RE: Docket No. 71-9007

Enclosed is a revision to drawing number 42402-01 which includes the source assembly models B-8-A and B-8-T as requested in your November 21, 1990 letter. Should you require any additional information regarding this request, please contact me at (617) 272-2000 extension 230.

TITLE: SOURCE TABLE  
 PART: 42402-1  
 SCALE: 1/8" = 1"

TITLE 		RADIATION PRODUCTS DIVISION BURLINGTON, MA 01803	
DRAWN BY 		CHECKED BY 	
DATE 6-12-90		CLASSIFICATION 42402-1	
SCALE 		SHEET 3 OF 3

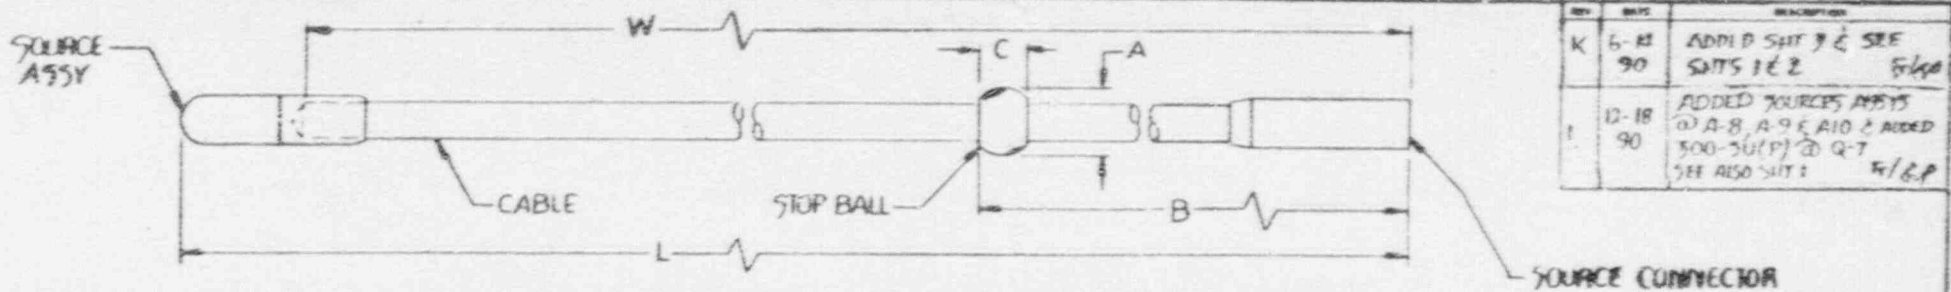
6	89912F (A-2-J)	IR192	120	B89902F	A87501	.150 DIA FLEX-SHAFT	A89900-10	7 11/16	7 1/8	2.56	.705	A89901-1	G.I. CENTURY 5A, 355A, G.N. 20V, 40V	5005U(G)		
7	B-8-A (88901)	IR192	120	B88901	A88702	1/8 7x19	801-8001-202	6 13/16	6 3/16	1.50	.705	801-1001-208	AUTOMATION 520	650, C10 500-5U(P)		
8	B-8-T (89701)	IR192	120	B89701	A88702	1/8 7x19	B55000-900	6 13/16	6 1/4	1.56	.705	A55000-A	A.I. 520	650, C10, 500-5U(P)		
9	931	IR192	120	A93100	A87502	.150 DIA FLEX-SHAFT	B55000-900	6.725	6.86	1.44	.705	A55000-A	A.I. 520	500-5U(P)		
10	932	IR192	120	A93200	A87502	.150 DIA FLEX-SHAFT	B55000-900	7 5/8	6.96	2.56	.705	A65000-A	SPEC 2T	500-5U(T)
